BID Addendum No. Five (5)

PROJECT: Iona Preparatory School
Addition and Alterations to the
Pail Verni Fine Arts Center
255 Wilmot Road
New Rochelle, NY 10804

ADDENDUM NO. Five (5)
Initiation Date: June 24, 2021

Architect's Project No.: 1618
PGA Contact: Danny Lam
dlam@petergisolfiassociates.com
914-478-3677 x 340

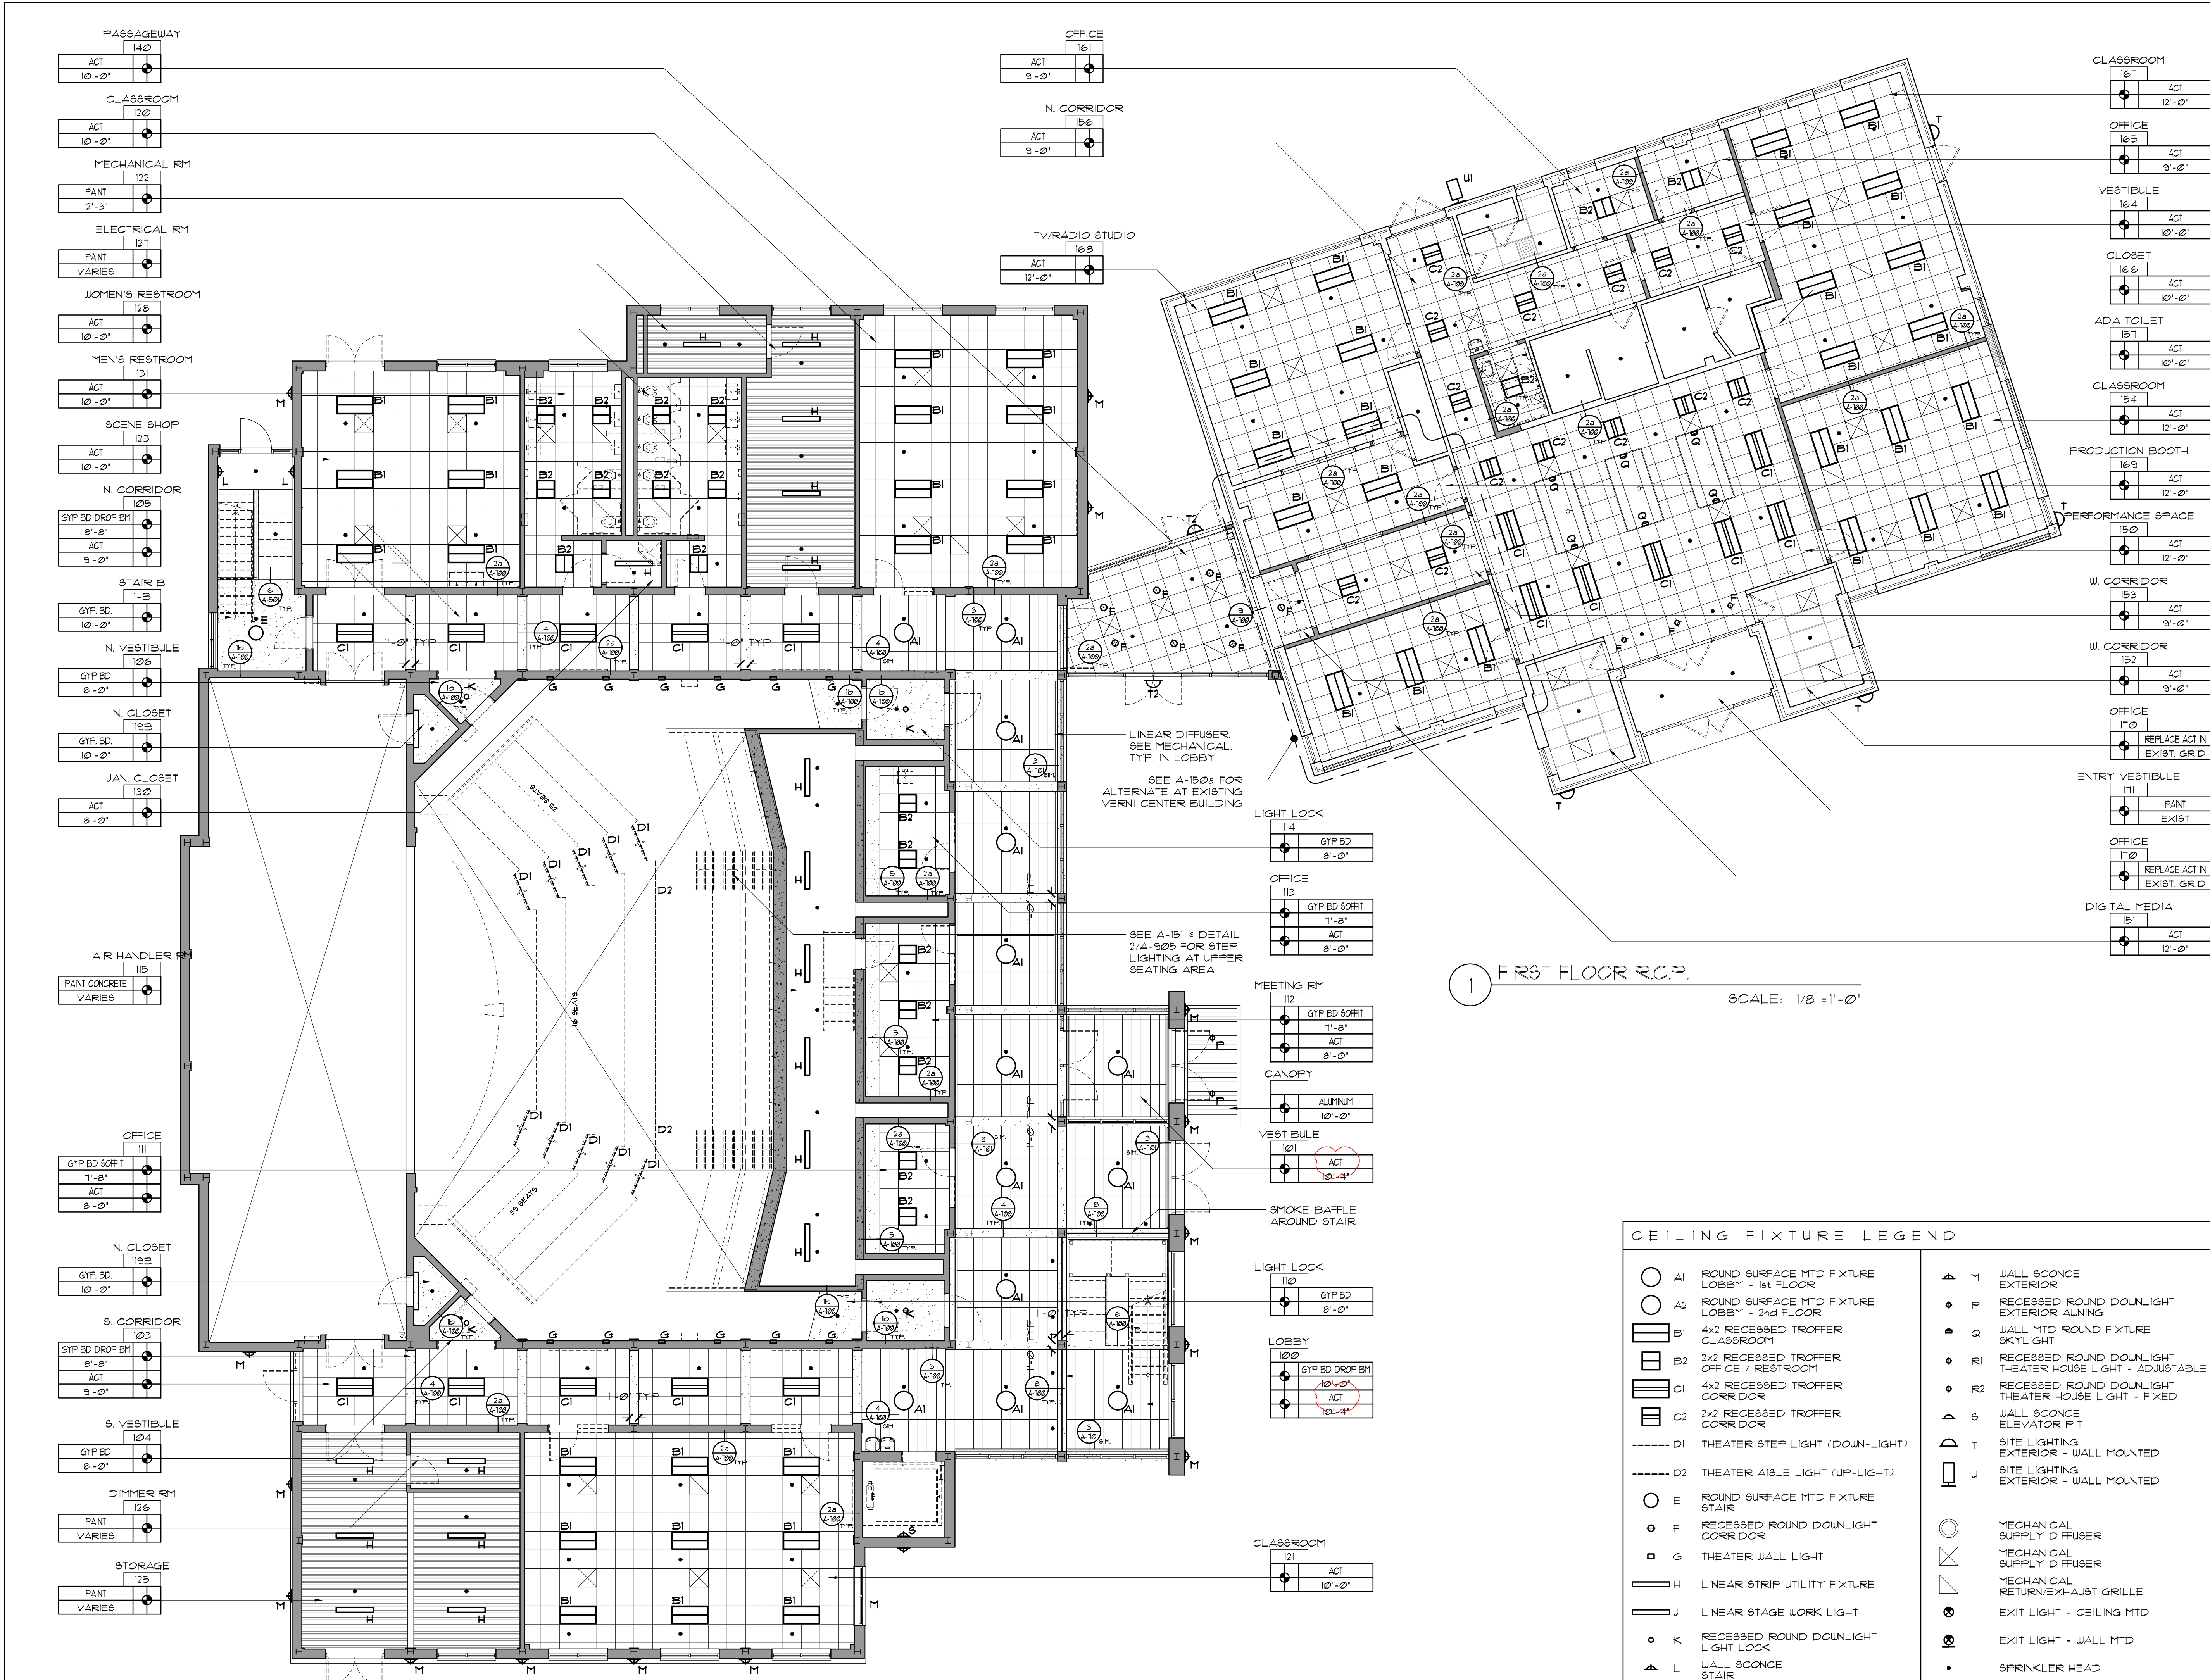
1. See attached revised sheets A-150 and A-151 with clarification to the 1st floor and 2nd floor lobby ceiling. Refer to A-950 Finish Schedule issued in addendum 1 for ceiling information.
2. Specification section 08 14 16 Flush Wood Doors – Paragraph 2.3(A)(5) note there are no sketch veneer doors for this project. Refer to door elevations on A-900.
3. All pilasters shown in the classrooms are painted gypsum board.
4. Specification section 10 11 00 Visual Display Surfaces – All markerboards/whiteboards shall be Claridge CONCEPT Dry Erase Board with aluminum trim and marker tray. All tackboards shall have wood trim per detail 1/A-600.

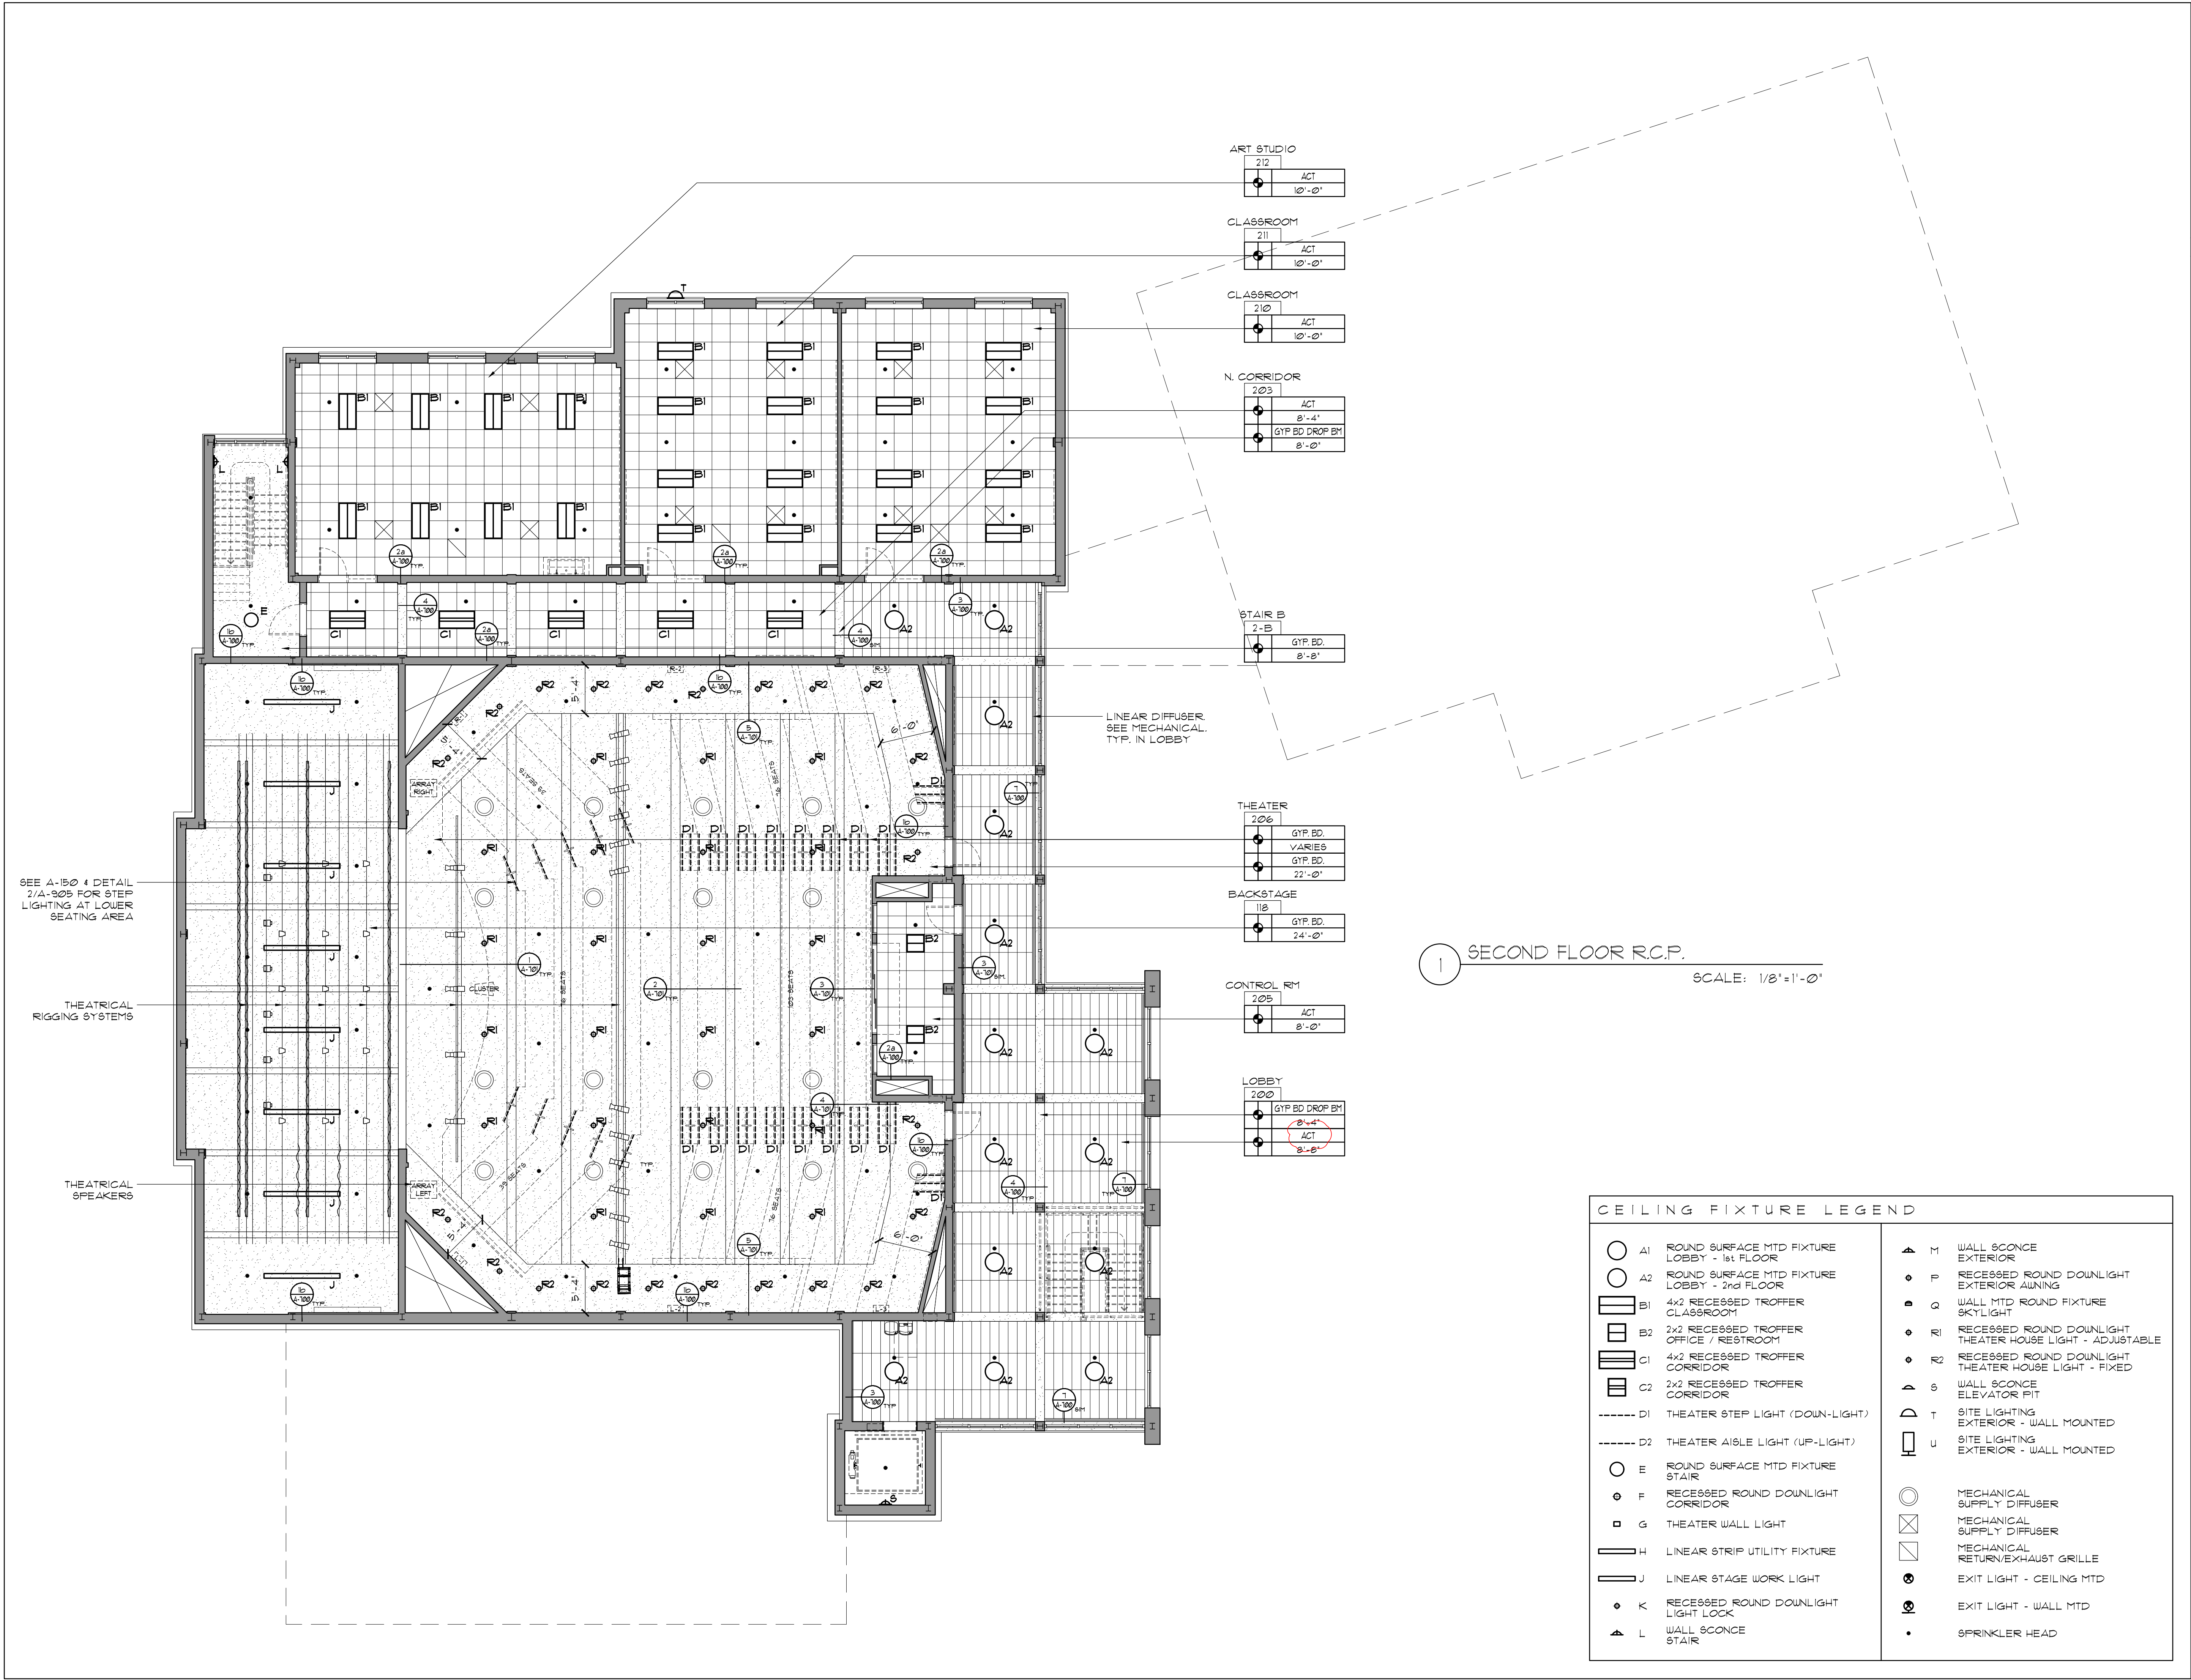
1. See attached revised sheet S-103 with revisions to roof truss spacing at the theater roof.
